MANAGER'S REPORT NO. 19

COUNCIL MEETING Mar. 11/74

Re: Strata Plan Approval Application #STA 3/74  
D.L. 29, Lot 65, Group 1, Plan 38396, N.W.D.  
7450 - 78 Thirteenth Avenue

MUNICIPAL PLANNING DEPARTMENT  
 SKETCH #1

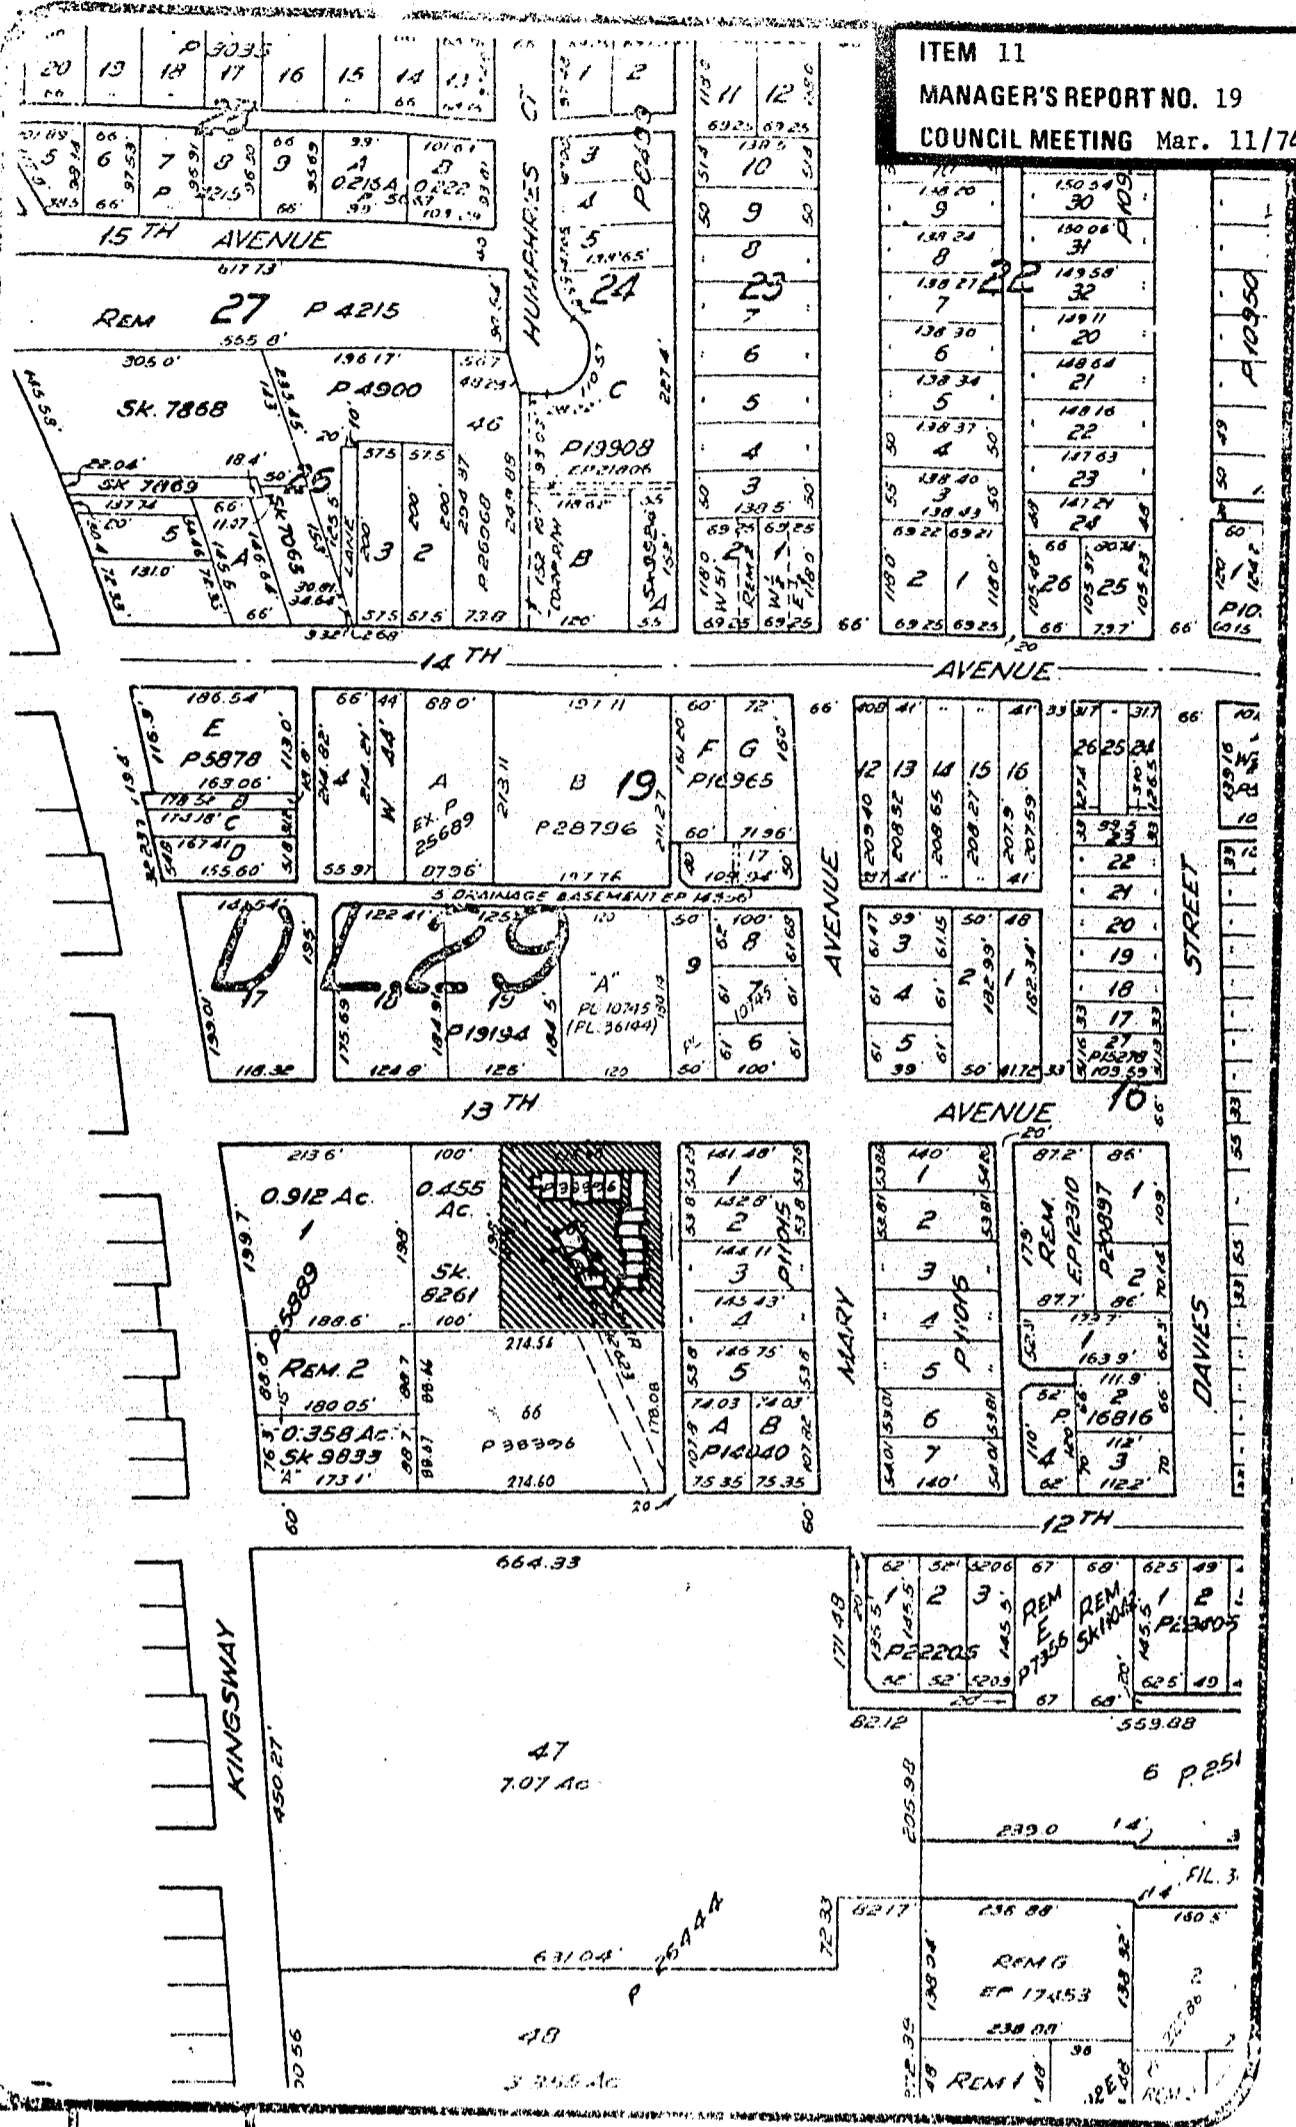
Through the Planning Department, the applicant has requested Council approval of the Strata Plan for a 15-unit townhouse development called "The Poplars" located on the south side of 13th Avenue between Kingsway and Mary Street (see Sketch 1 attached).
